City of Portland
Bureau of Development Services
Land Use Services Division

NOTICE OF A TYPE II DECISION ON A PROPOSAL IN YOUR NEIGHBORHOOD

CASE FILE NUMBER: LU 08-116125 AD

Site Address: 14126 SE DIVISION ST

S.E. DIVISION ST.

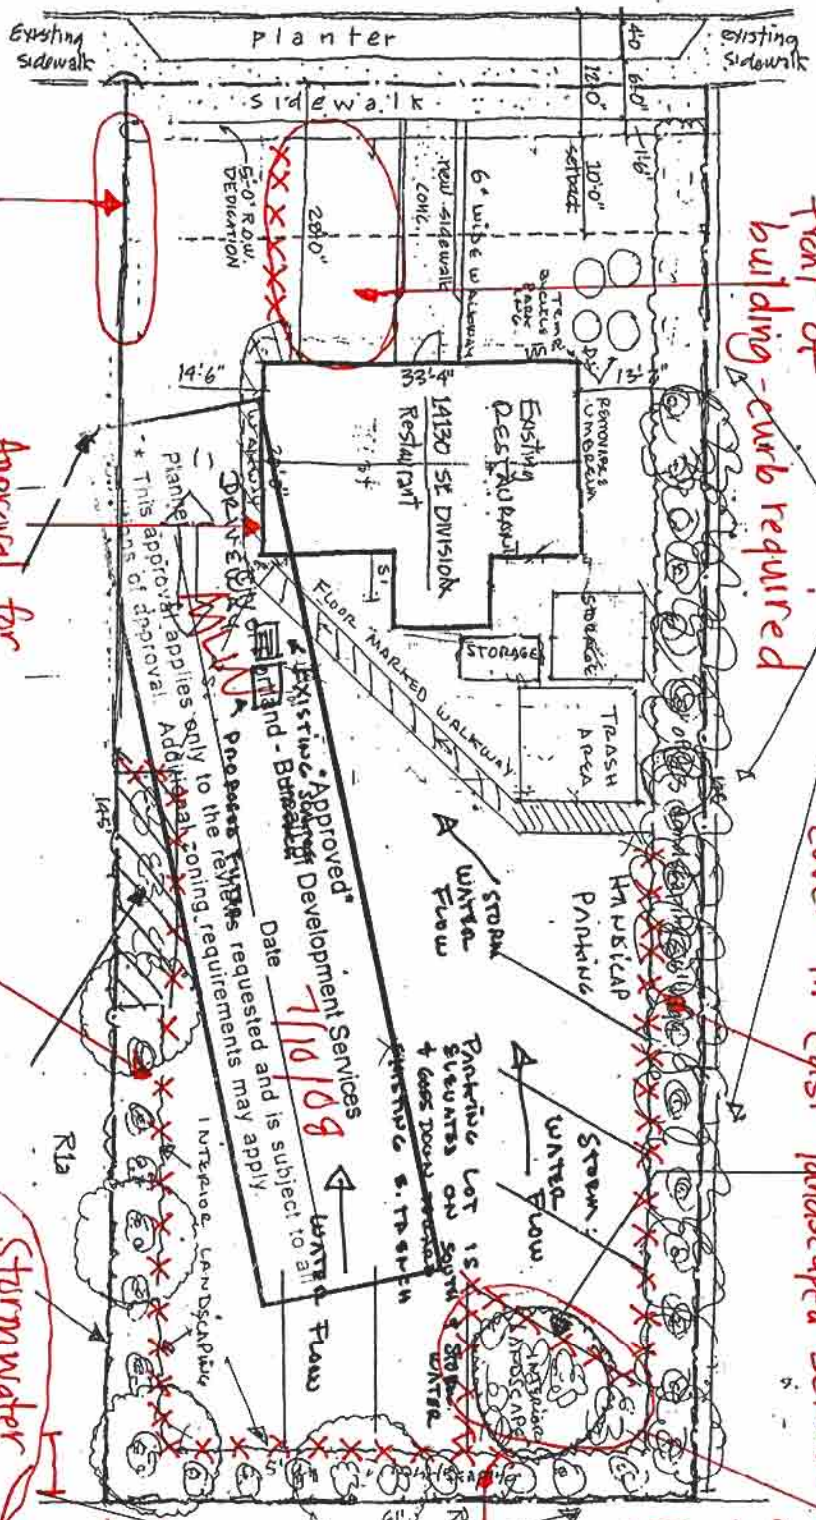
No parking allowed in front of building - curb required

Building permit required

Approval for existing laurel hedge to substitute for trees, shrubs and ground cover in east landscaped setback

Additional 290 square feet of landscaped area required to be planted with one tree + eight shrubs

Three medium sized trees and 13 shrubs required within south landscaped setback

Increase depth of landscaped setbacks to 5 feet

Stormwater requirements must be met as determined by site development and/or RES
XXX = 4" inch curb required

Three medium-sized trees and 18 shrubs required within west landscaped setback

Approval for ped. connection to be located within driveway + designated with striping

Location where wooden fence no more than 42 inches in height is required
